## **Honda Civic, from model year 2001 Jazz, from model year 2002**

### **New clip connection**

# Bulletin

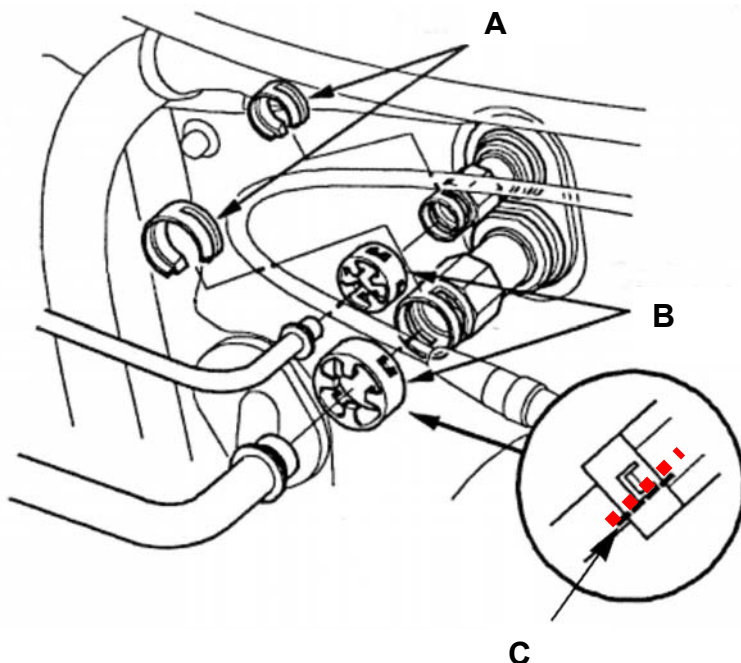
New clip connections are being used in the area of the evaporator in the above-mentioned vehicles. These connections consist of a retaining clip (Pos. A) and safety ring (Pos. B) and serve to form a connection between the pipeline and the evaporator. The connection can be loosened only by cutting the safety ring along the line shown (Pos. C). New clip connections must be used during assembly. Care must be taken to ensure that the flat collar of the retaining clip is mounted in the direction of the O-ring.
